DEPARTMENT OF HEALTH, EDUCATION, AND WELFARE
PUBLIC HEALTH SERVICE
FOOD AND DRUG ADMINISTRATION

October 6, 1980

Following is the additional information you requested in your letter of August 25, 1980 to our amendment of License No. 04-09763-01. It represents some discussions between yourself and Neil Gaeta, our consultant Health Physicist.

Main
Microbiology Laboratory

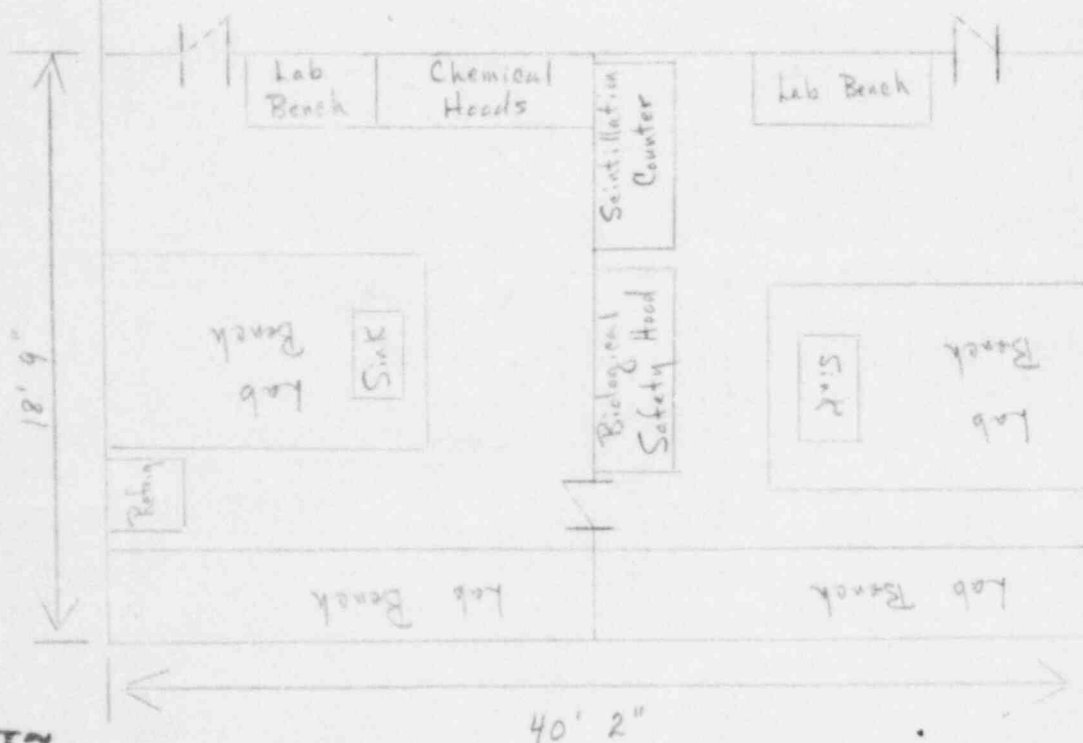
Comment 6: See attached diagram.
